# SAFETY RECALL NOTICE

## Re: Can-Am™ Roadster – Fuel Cap Replacement

**SAFETY**  
CAMPAIGN**ROADSTER**  
**WARRANTY**  
Bulletin**⚠ WARNING:** All involved customers must be notified, all involved units must be corrected as per instructions herein.Campaign no.: 2008-0011  
2009-0007  
2010-0015  
2011-0019  
2012-0013December 21, 2012 Subject: **Can-Am™ Roadster - Fuel Cap Replacement** No. **2012-13**

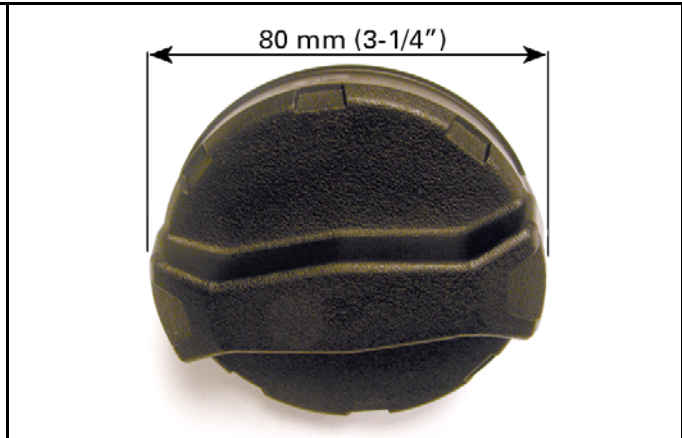
Remove and discard vehicle's fuel cap.

Install the new improved fuel cap.

**NOTE:** For reference, please see below pictures that will help you identify the new fuel cap which has a reddish color seal AND a different size handle.

**Identification of new and improved fuel cap**

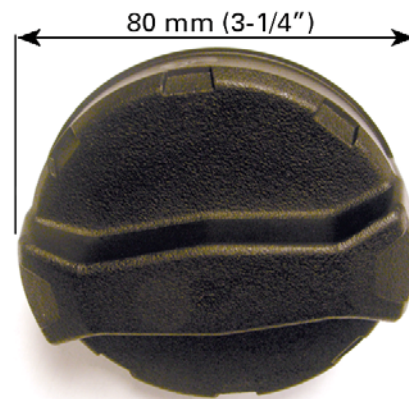
For reference, please see below pictures that will help you identify the new fuel cap which has a reddish color seal AND a different size handle.
